Service Bulletin

no. 76-5

Subject: **BETOR FORK KIT (PART NO. 749 008 000)**

Service Bulletin

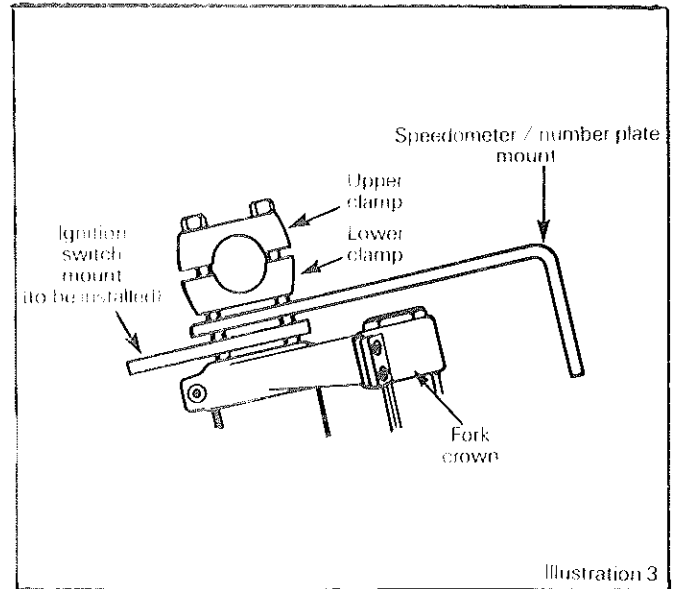
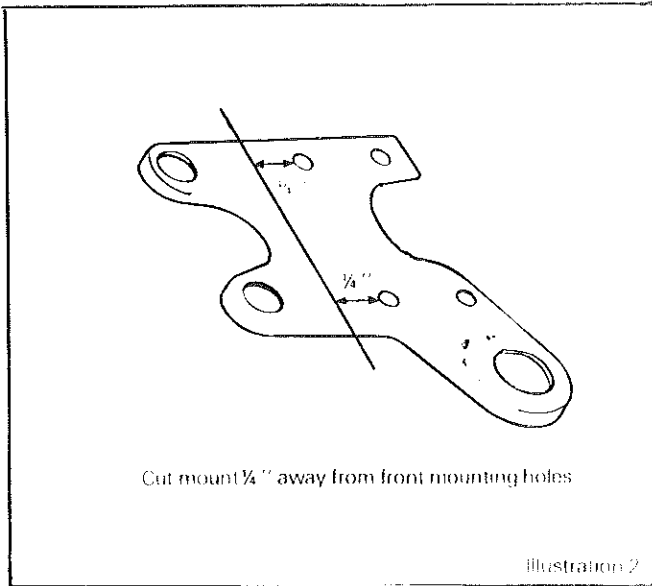
On models equipped with the Enduro kit speedometer/number plate mount, the ignition switch mount should be modified as per illustration (2) before installation.

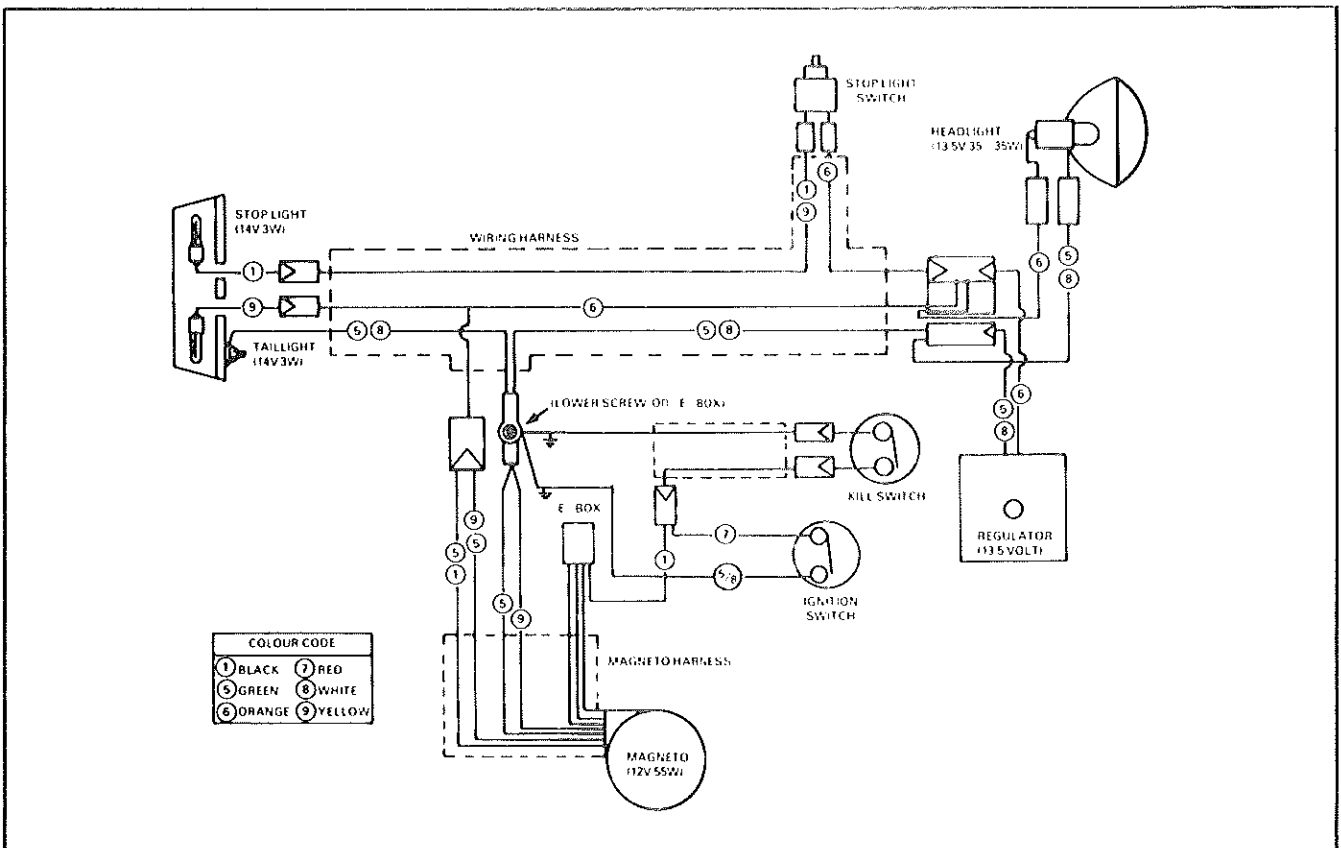
1. Remove the handlebar clamp bolts and slide the modified ignition switch mount under the speedometer/number plate mount. Replace the clamp bolts and tighten them securely (See illustration 3).

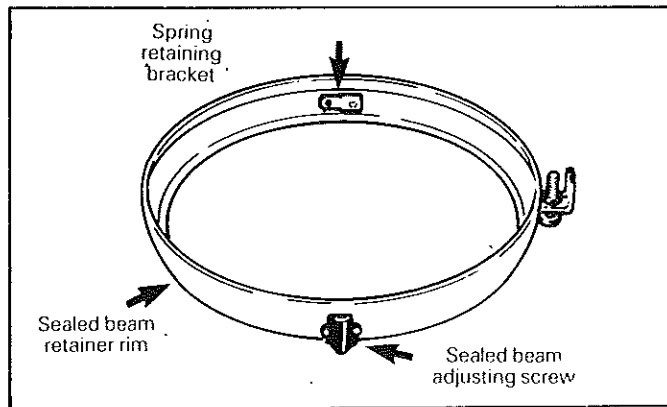
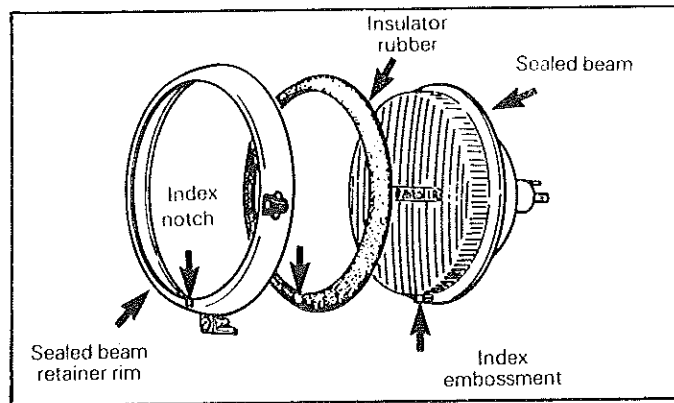
Now that the headlight aiming screw device is no longer required by legislation, the sealed beam mount may be up-graded to our 1977 set-up. (i.e.: sealed beam rubber mounted in rim using 2 rubber rings similar to our 1973/74 set-up).

- Remove and discard the damaged sealed beam. Modify the sealed beam retainer rim by pressing spring retaining bracket flush with the rim body.

- Fit the insulator rubber into the retainer rim with the sealed beam on top. Making sure to align the index embossment of the sealed beam with the index notch of the insulator

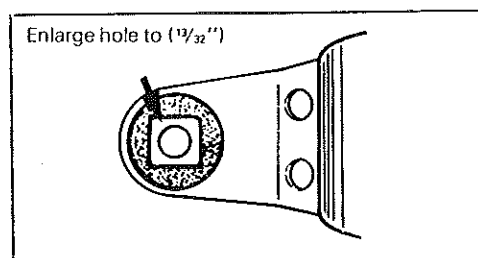
For head light aiming, enlarge the hole in the square spacer (drill $13/32''$) to provide more side to side movement for the fixing screw.

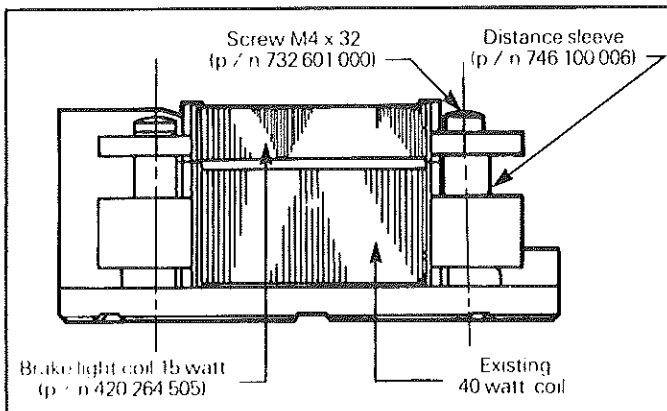
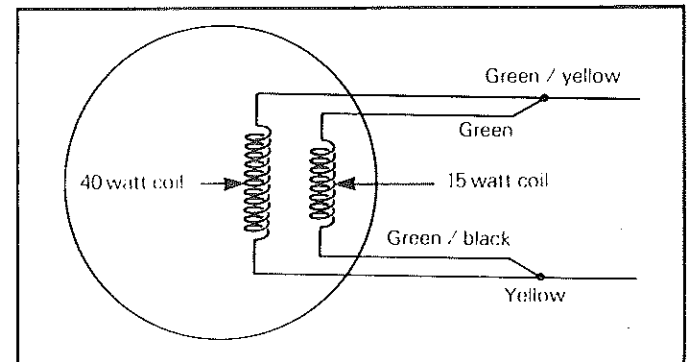
- Connect the new coil wires as illustrated.

CAUTION: The green / black wire should be routed under the 40 watt coil to prevent the wire from rubbing on the magneto flywheel nut.

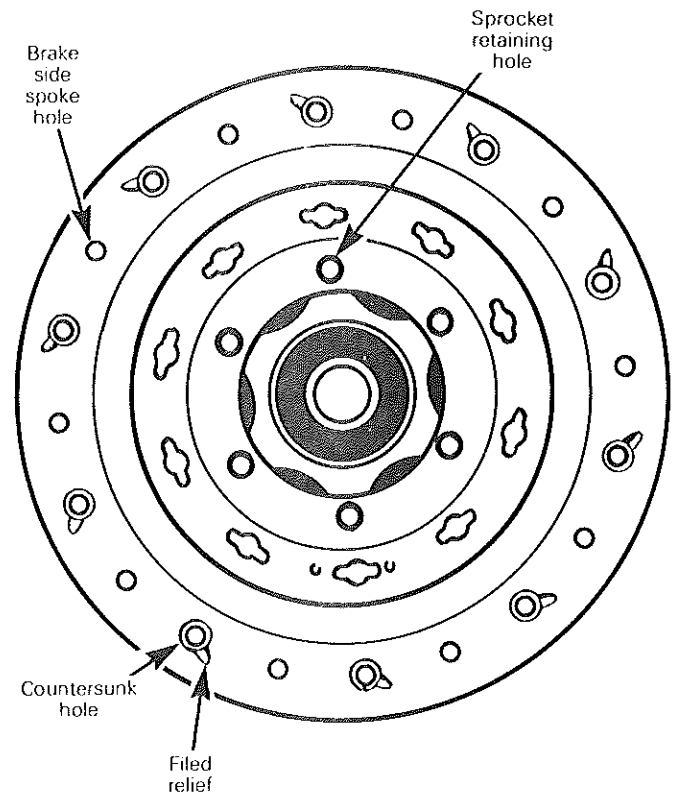
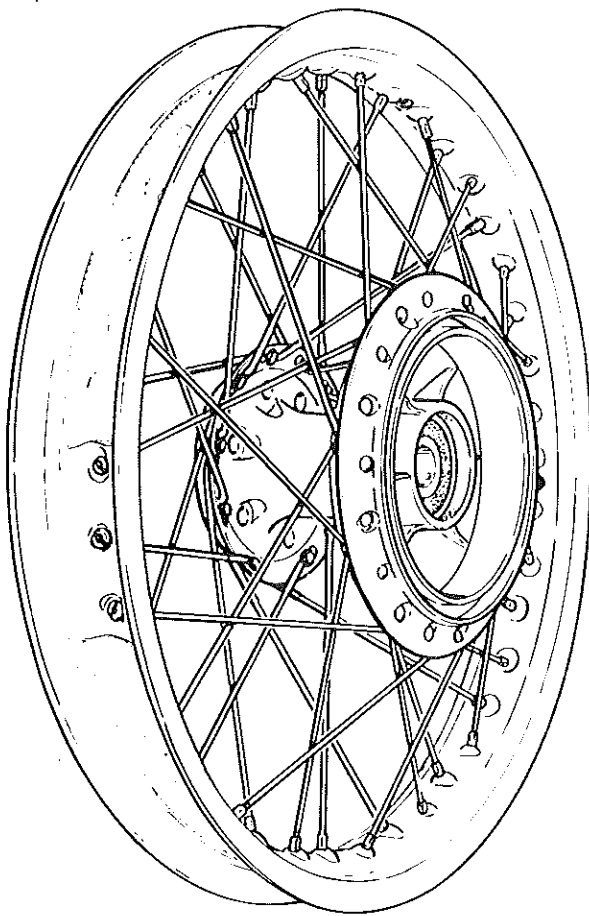
In order to further improve the strength of the 1974 and later model Can-Am motorcycle rear hubs the rear wheel may be laced with all spokes on the brake side mounted on the inside of the hub.

○ **NOTE:** If this procedure is to be performed on a wheel which is already laced, take the wheel completely apart and discard all the brake side outer spokes and replace them with 10, 743 012 007 L.H. (brake side) inside spokes.

- 10 - 743 012 008 R.H. outside (sprocket side)
- 10 - 743 012 009 R.H. inside (sprocket side)
- 20 - 743 012 007 L.H. inside (brake side)

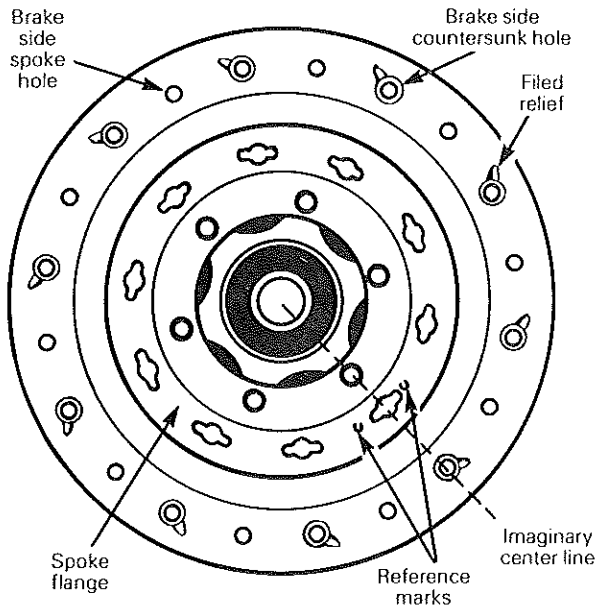
A small relief should be filed into the edge of the countersunk hole on the inside of the hub to eliminate the slight binding which occurs. (See illustration).

○ **NOTE:** Only a small amount of aluminium needs to be removed.
